<i>Project</i>	IEEE 802.16 Broadband Wireless Access Working Group < http://ieee802.org/16 >	
<i>Title</i>	Optimization of channel distribution	
<i>Date Submitted</i>	2006-02-28	
<i>Source(s)</i>	Pan Zhong, Wu Xuyong, Zhao Quanbo Huawei Huawei Industrial Base, Bantian, Longgang, Shenzhen 518129 P.R.C	Voice: +86-755-28971675 Fax: +86-755-28972149 panz@huawei.com wuxuyong@huawei.com zhaoquanbo@huawei.com
<i>Re:</i>	80216h-06_005: Call for Comments and Contributions: IEEE 802.16 License-Exempt Task Group (2006-02-06)	
<i>Abstract</i>	Base on 3 cases of channel switching allowance, we find the capacity of the channels is quite different, study on the result and continue on, we may discuss on choosing the method of ACS. Allowing channel request in the neighborhood may be a realistic tradeoff between performance and complexity.	
<i>Purpose</i>	Propose a realizable optimization of channel distribution

Optimization of channel distribution

Figure h26a—Process of channel distribution optimization

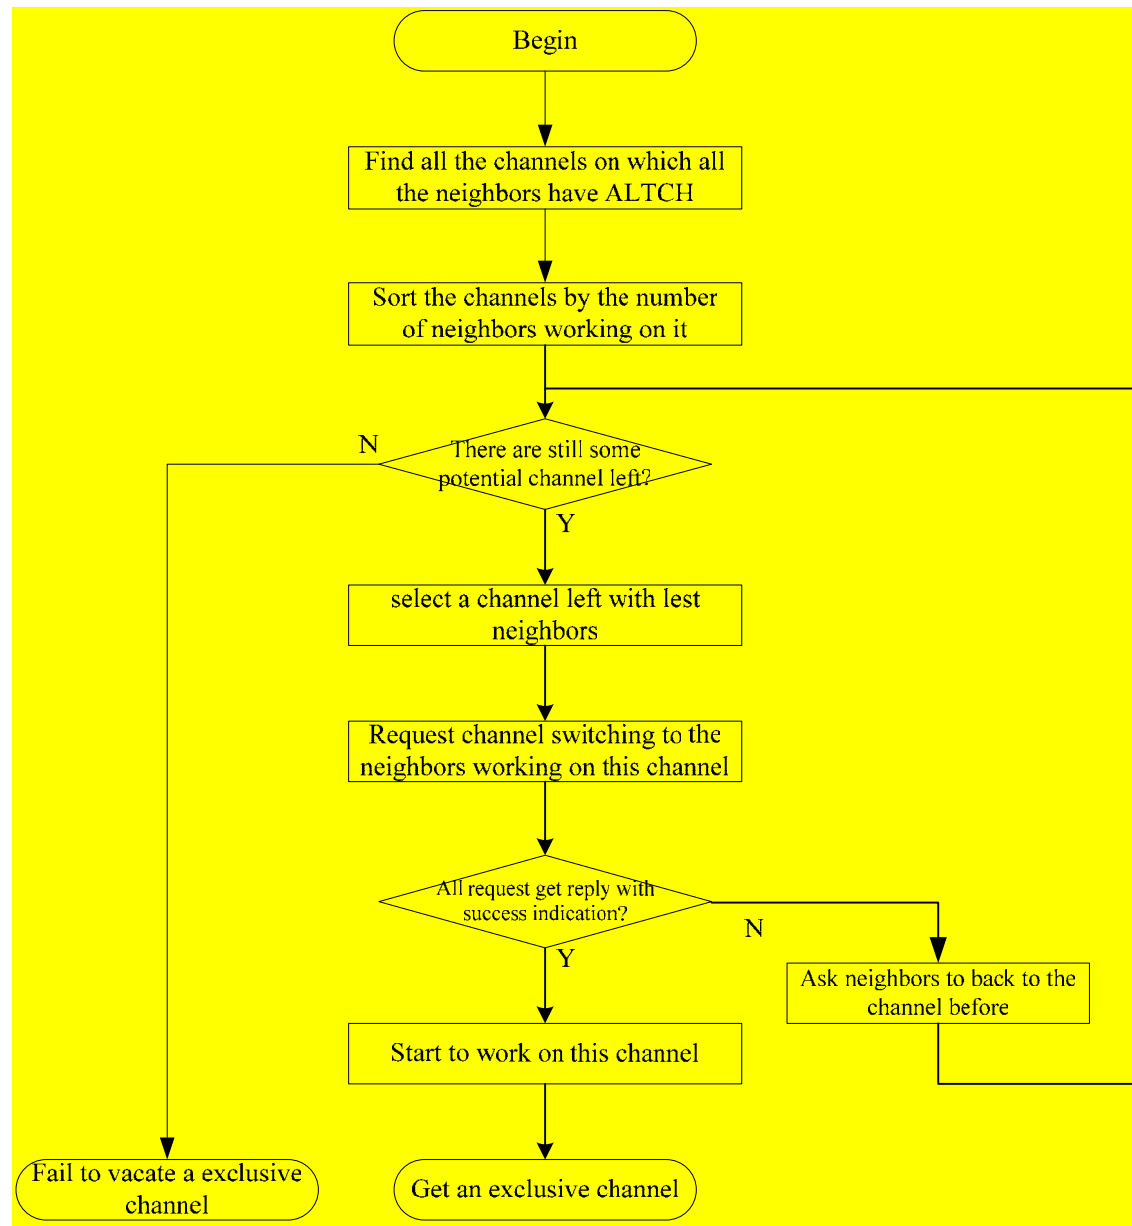
In the initialization phase of an IBS, IBS's neighbors will send their current OCTS allocation or subframe allocation to IBS using CP message, as well as a flag of having alternative escape channels. IBS may maintain the channel information of all neighbors in BS information table.

When IBS cannot find any free channels for itself at the initialization, channel distribution may be optimized to vacate a free channel for IBS by switch some neighbors' working channels to others.

First, IBS picks up all the channels that every neighbor working on it has alternative escape channels, and sorts them according to the number of neighbor BSs working on it.

Afterwards, IBS selects one of the channel used by lest BS, and considers this channel as its potential working channel. The neighbors working on the selected channel are to be negotiated.

Then, to negotiate to every neighbor BS working on this channel, IBS should send channel switch request message. Neighbor OBS which have received this message should select one of its alternative channels as the its target working channel, and try to move its working channel to that channel as long as the request is qualified. After its working channel switch to its alternative channel, The neighbor OBS should acknowledge to IBS by sending back channel switch reply message with success indication, otherwise it should show rejection to IBS by sending back channel switch reply message with fail indication. If IBS received any rejection from the neighbors which IBS have sent the request, IBS should cancel the request by sending another message with the indication for the neighbors to back to the channel they used before the IBS's channel switching request.

When IBS receives all the acknowledged messages, it means the channel distribution optimization procedure has succeeded to vacate a channel for IBS. Otherwise, IBS should try the next channel.

In the case of success of the optimization procedure, list of alternative escape channels of relative BSs should be updated because its neighbors may change their working channels. For IBS, it should broadcast to all its neighbor that it will working on the selected channel, and all its neighbors should add IBS as its new neighbor in BS information table, and exclude IBS's target working channel in the list of alternative escape channel. For the neighbor OBSs working on this channel, they also should notify their change to all their neighbors for their switching from its current working channel to another, so their neighbors can update the database and their alternative channel according to that change.

If all the potential channels can not be vacated to become IBS's working channel, channel distribution optimization procedure is failed, and IBS shall try to share one channel with some of its neighbors.

The process of channel distribution optimization is shown in Figure h26a.
